AURIX™ TC27x errata sheet

Marking/Step: ES-DC, DC

10500AERRA

Figure 3 Message RAM configurations

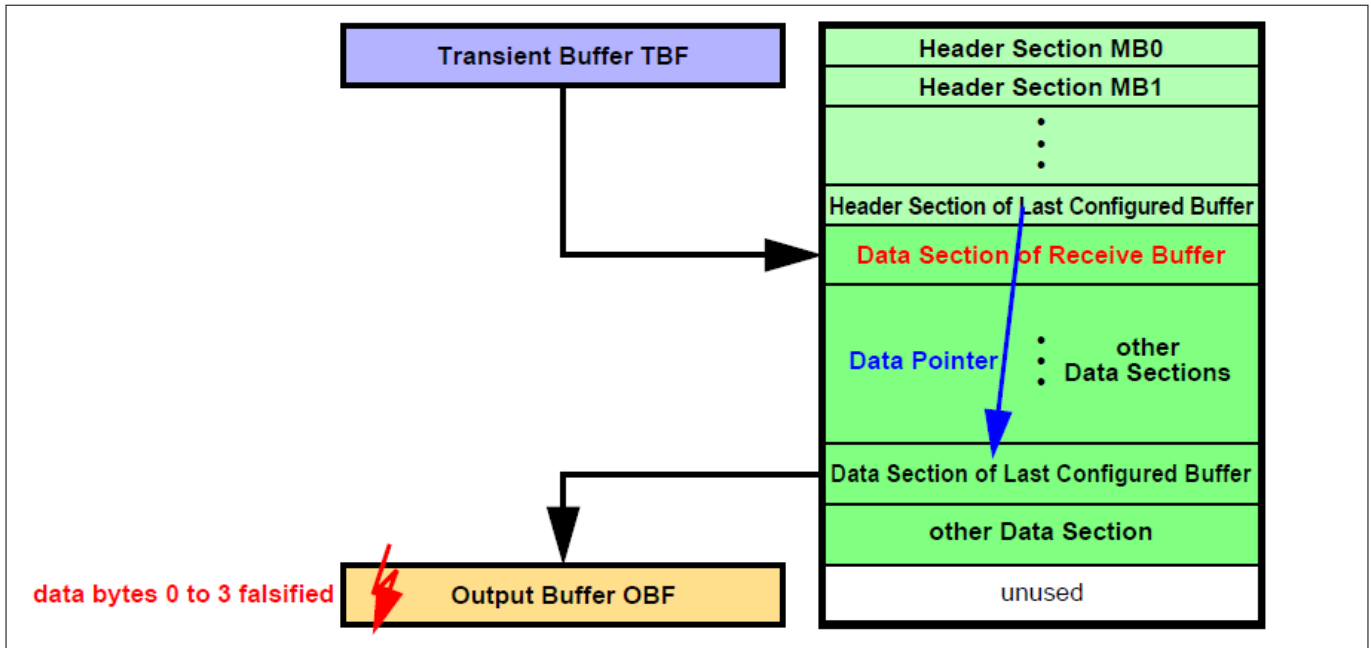
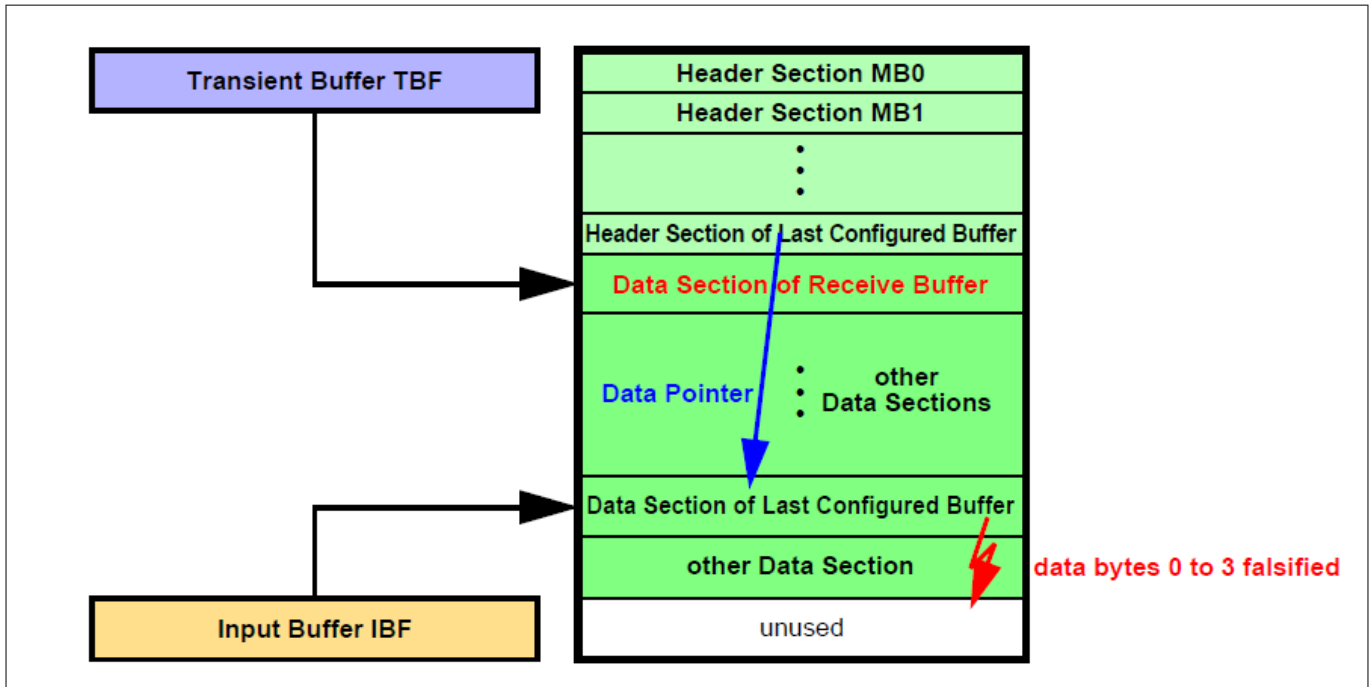
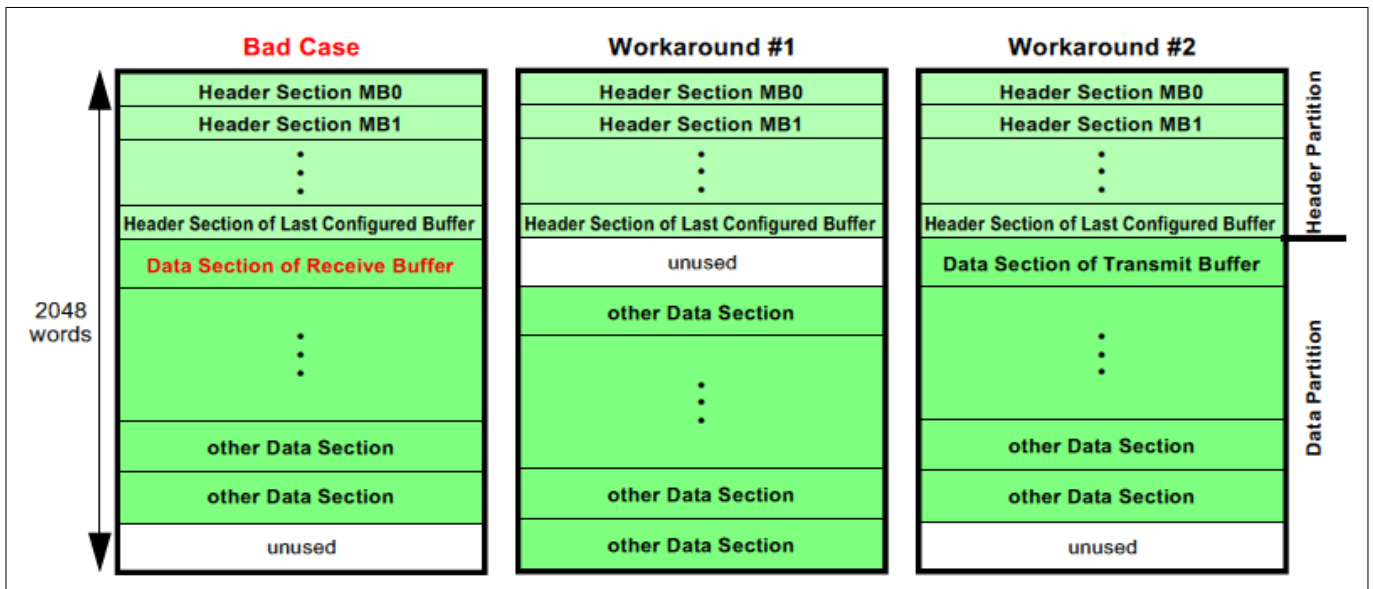
When the message buffer has its payload configured to maximum length (PLC = 127), the OBF word on address 00h (payload data bytes 0 to 3) is overwritten with unexpected data at the end of the transfer.

After the Data Section of the selected message buffer in the Message RAM has been written, one additional write access overwrites the following word in the Message RAM which might be the first word of the next Data Section.

- a) When a message is transferred from the Last Configured Buffer in the Message RAM to the OBF and PLC = 127 it may happen, that at the end of the transfer the OBF word on address 00h (payload data bytes 0 to 3) is overwritten with unexpected data (see [Figure 1](#))
- b) When a message is transferred from IBF to the Last Configured Buffer in the Message RAM, it may happen, that at the end of the transfer of the Data Section one additional write access overwrites the following word, which may be the first word of another message's Data Section in the Message RAM (see [Figure 2](#))

Ensure that the Data Section directly following the Header Partition is assigned to a transmit buffer.

Figure 4 PLL Unlock Event Glitch

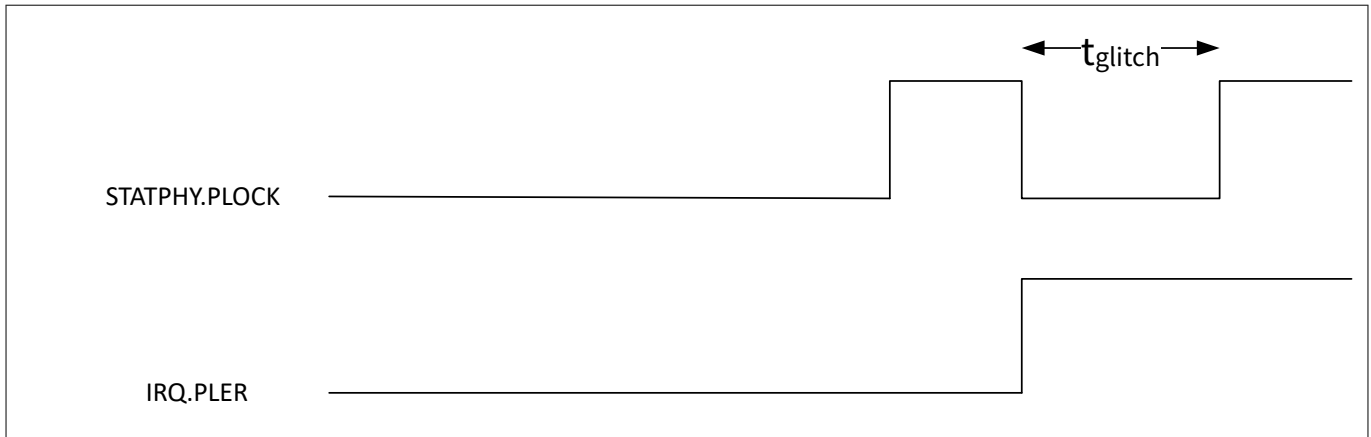
After STATPHY.PLOCK shows lock status, there is a possibility that the PLL is unlocked once for a short time (t_{glitch}) again at start-up phase, as shown in the figure below. This single unlock event as indicated by STATPHY.PLOCK recovers back to lock status without any software intervention.

The minimum time duration of t_{glitch} is 224 cycles of the PLL reference clock (RefClk). An example of minimum t_{glitch} duration for RefClk with 20 MHz and 10 MHz is shown in the table below.

Figure 5 Example sequence showing how registers ETRRx may be filled with “Error Free” addresses

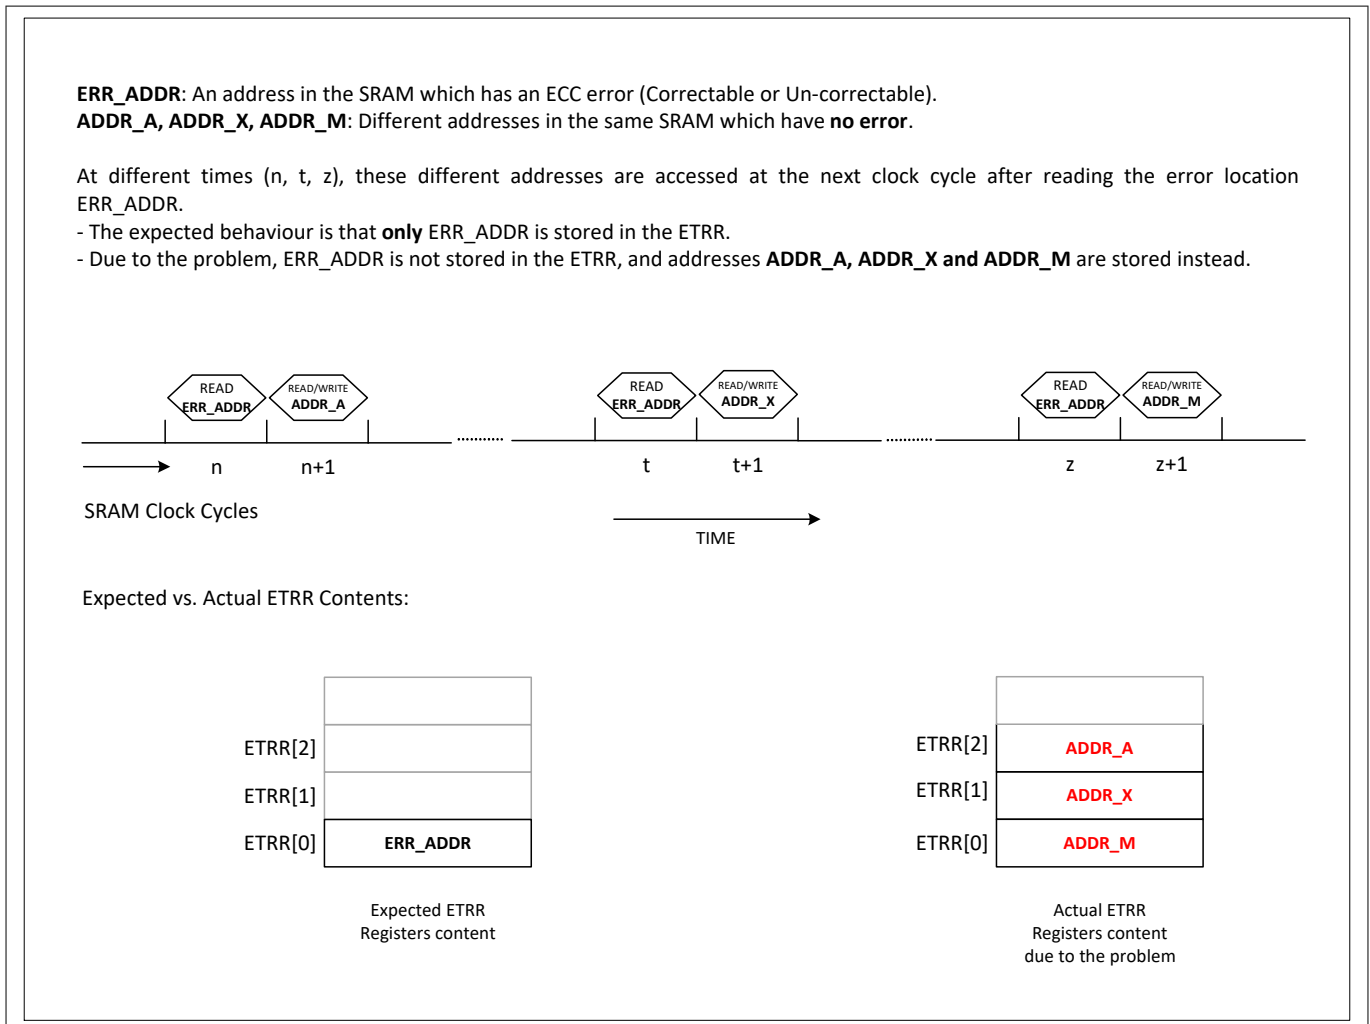
When such a consecutive access sequence (read from ERR_ADDR followed by read/write of different address(es)) happens multiple times, registers ETRRx are filled with addresses that have actually no error – and the SRAM address which actually has an error is not stored indeed. Figure 5 shows such an example scenario.

The consequence of the scenario explained in Figure 5 is that a single error in the SRAM – example just one correctable error at a location ERR_ADDR – can result in registers ETRRx getting filled with fault-free address, and thus potentially even triggering an ETRR overflow.

Figure 6 Recommended Software Handling - Flowchart

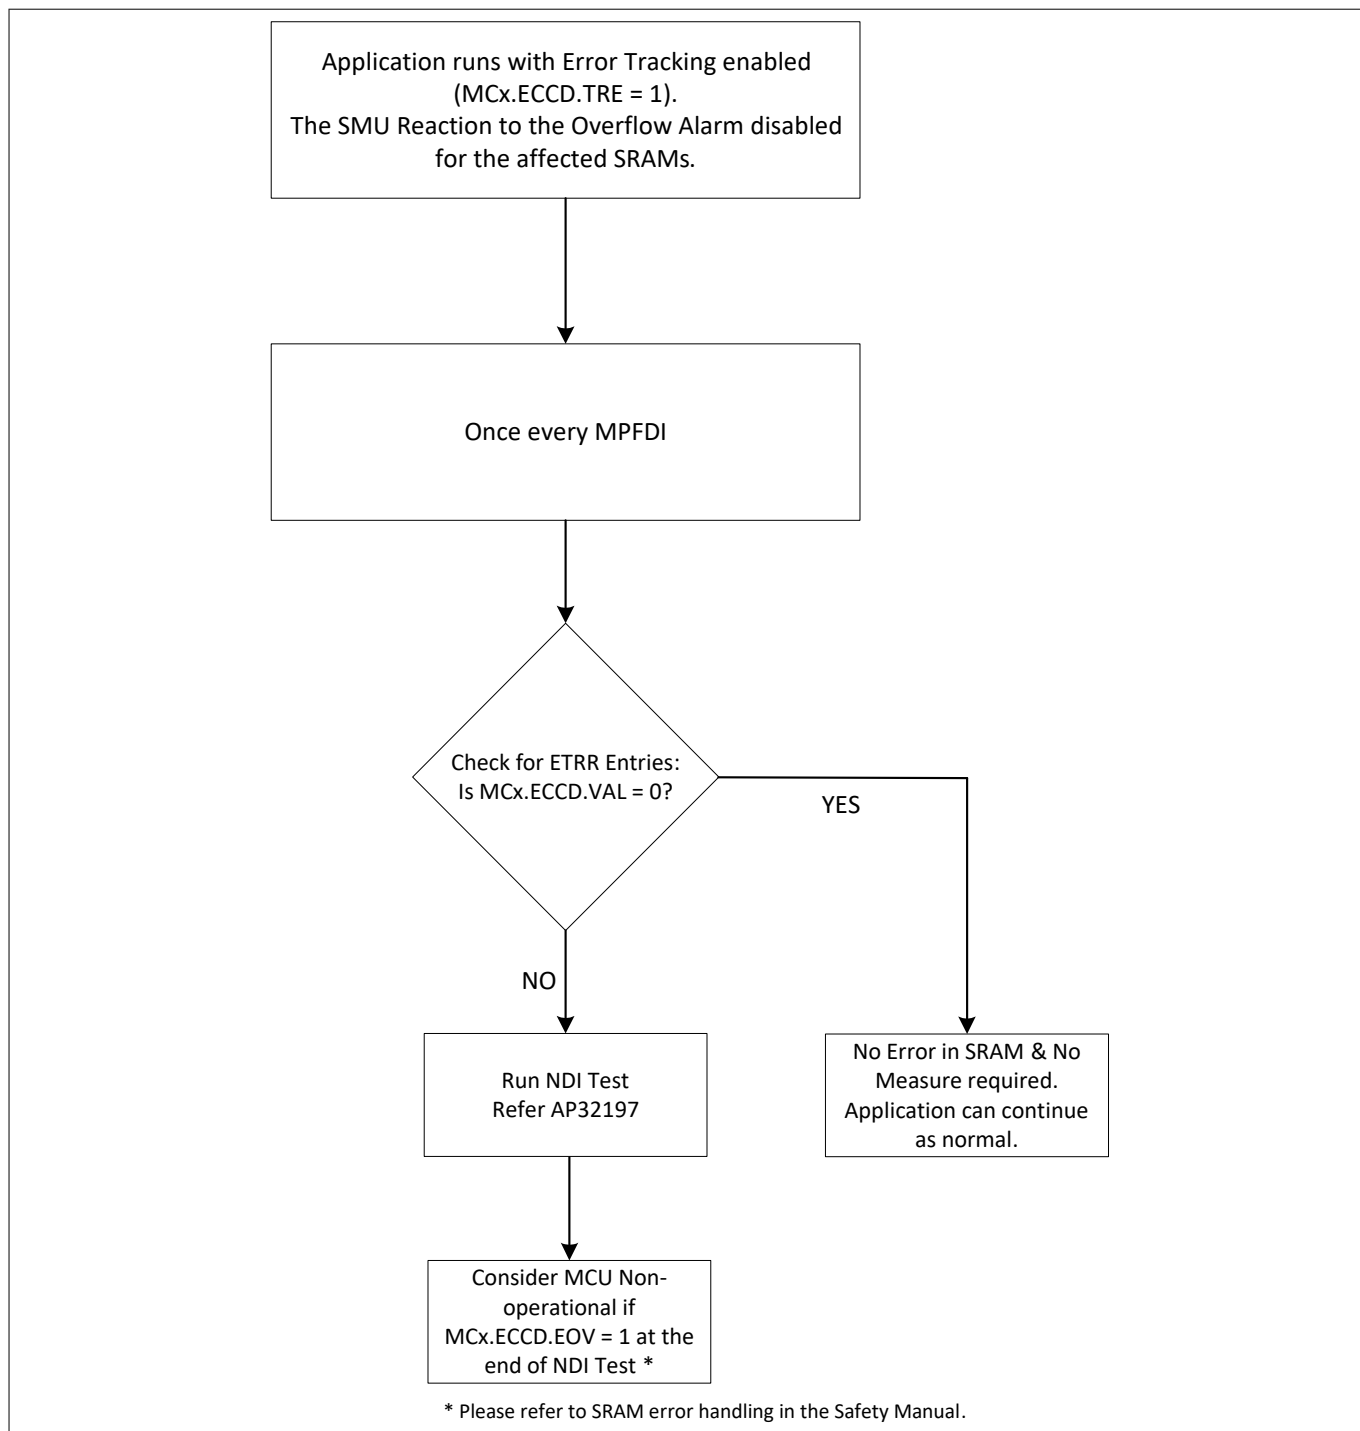
1. For the affected SRAMs, the addresses stored in ETRRx may not be reliable. Depending on the access sequences, ETRRx may contain the correct error address, or in the worst case all ETRRx entries may contain fault-free addresses
2. Depending on the access sequences, an ETRR overflow might be triggered with one real error (for example correctable error) in the SRAM – consequence of the example shown in [Figure 5](#)

A flowchart of the recommended software handling is shown in [Figure 6](#).

At the end of this test, if an ETRR overflow is detected ($MCx.ECCD.EOV = 1_B$) then the MCU shall be considered non-operational. Refer to section on Correctable SRAM Error handling in the Safety Manual.

Figure 16 Package Outlines LQFP-176 for TC27x

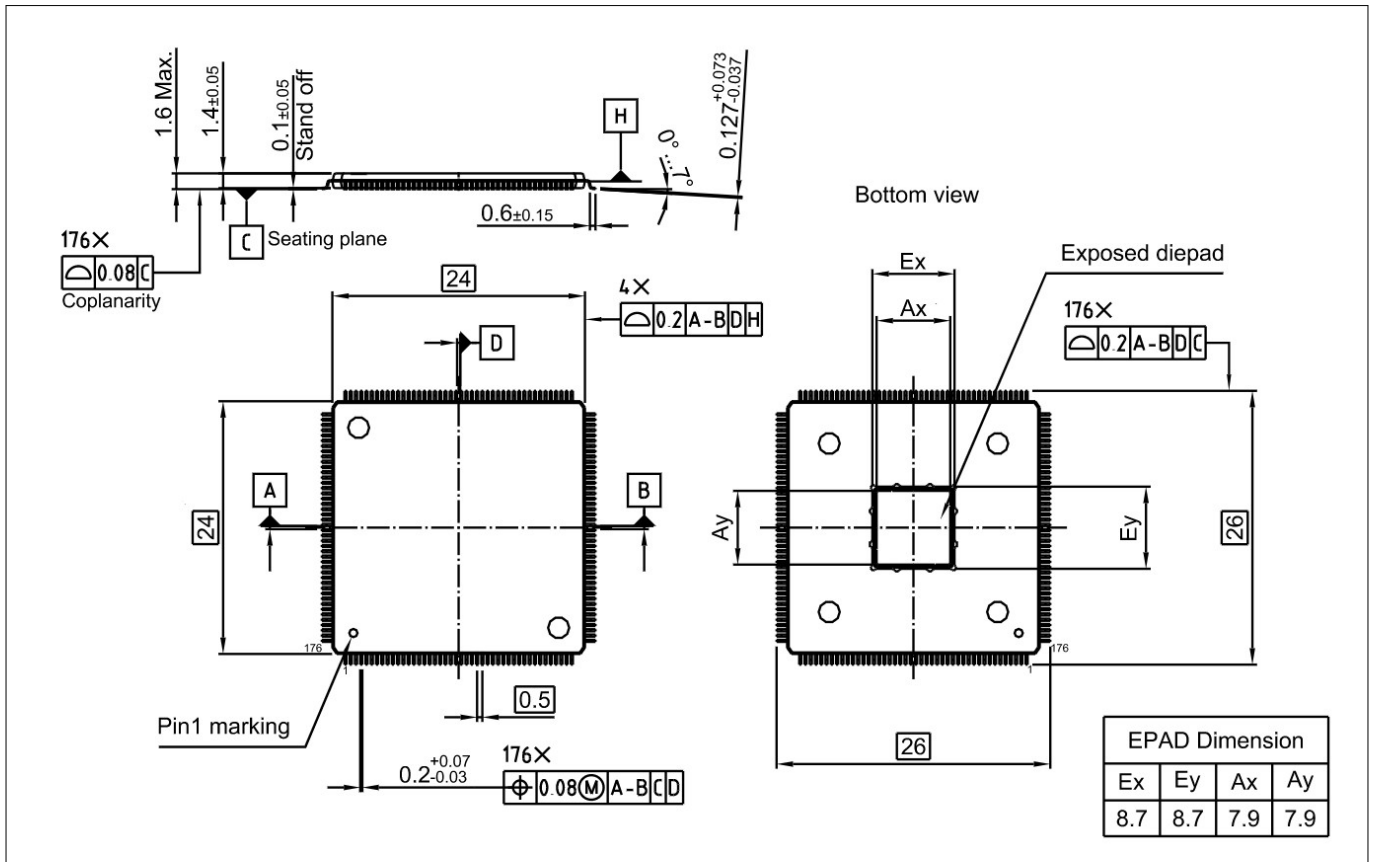
This information shall substitute the corresponding information in the TC27x CA-step Data Sheet V1.1, TC27x DB-step Data Sheet V1.2, and TC27x DC-step Data Sheet V1.2.

Note: For the exposed pad of the LQFP-176 package of the TC27x, structural corner protrusions have to be considered for purposes of system design and integration with a maximum boundary of 9.4 mm.

Figure 19 SENT Tolerance of this Design Step

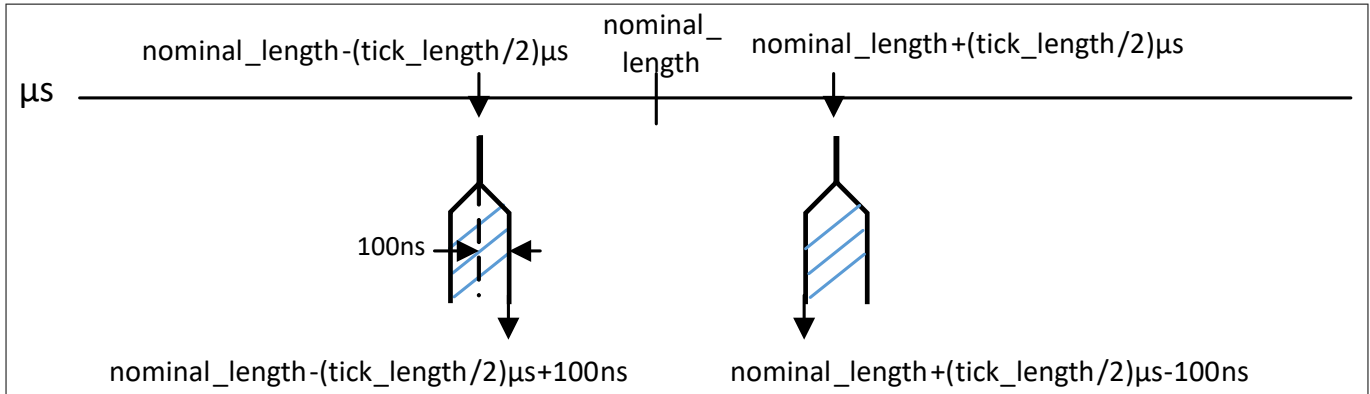
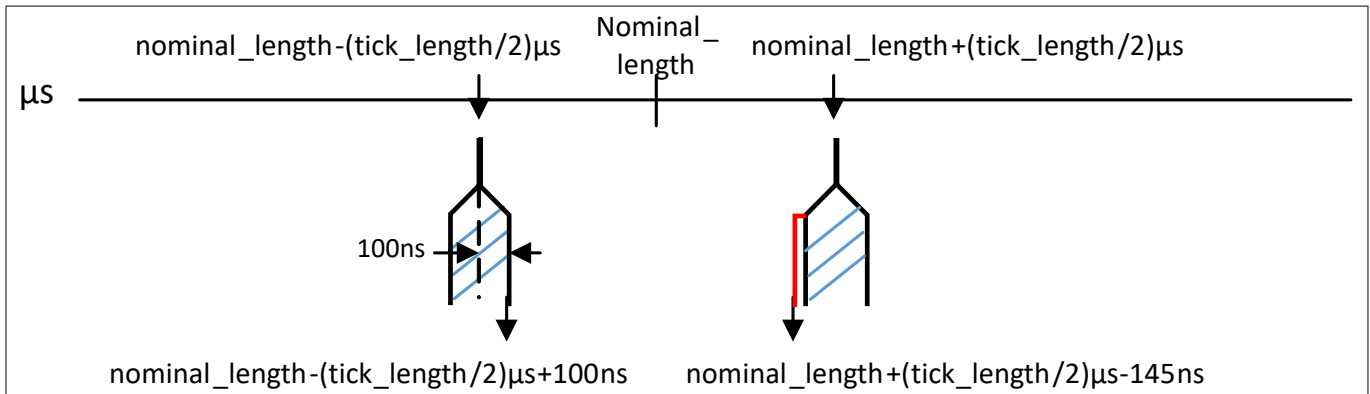
The length of a nibble in the SENT protocol determines the value of this nibble. For each value this length can vary, but it has to be at least inside a given range. This range is given by the SENT standard.

- The lower border is $\text{nominal_value} - (\text{tick_length}/2) \mu\text{s} + 100 \text{ ns}$
- The upper border is $\text{nominal_value} + (\text{tick_length}/2) \mu\text{s} - 100 \text{ ns}$

In this design step the range is delimited as follows:

- The lower border is $\text{nominal_value} - (\text{tick_length}/2) \mu\text{s} + 100 \text{ ns}$
- The upper border is $\text{nominal_value} + (\text{tick_length}/2) \mu\text{s} - 145 \text{ ns}$

Figure 20 Short Serial Message, Serial Data Encoding over 16 messages

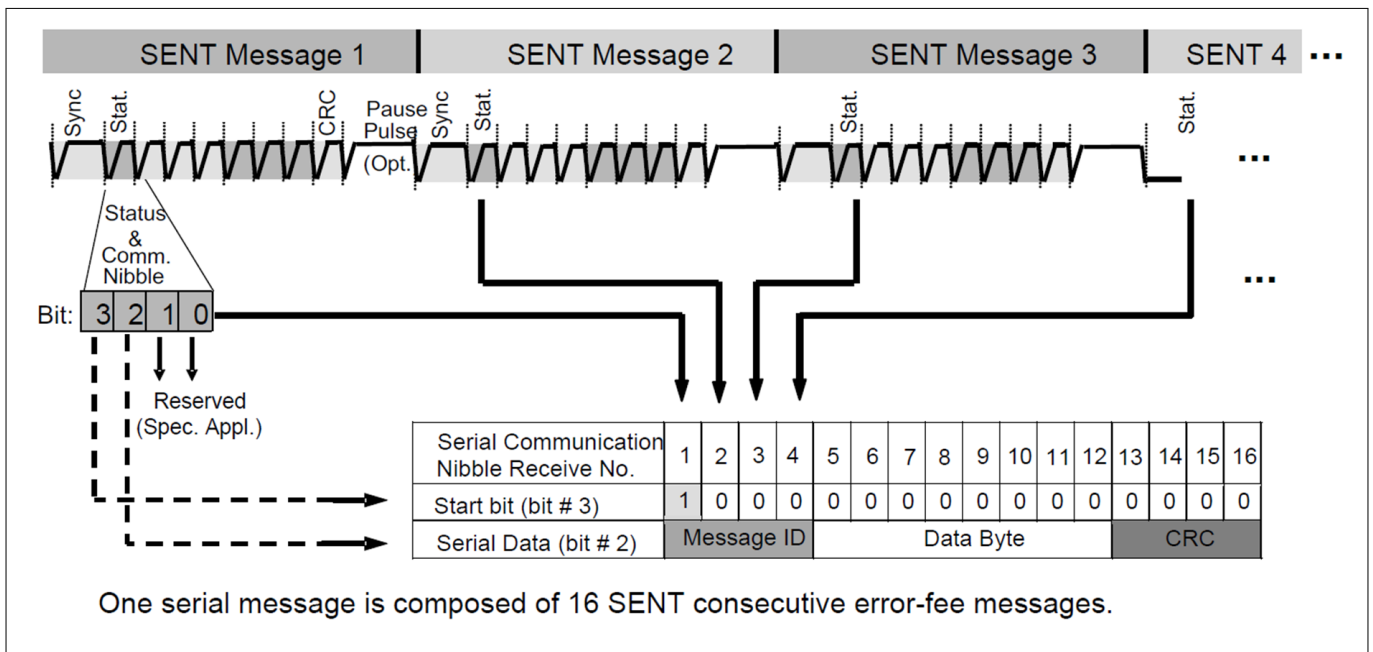
Figure 20 shows a corrected version of this figure.
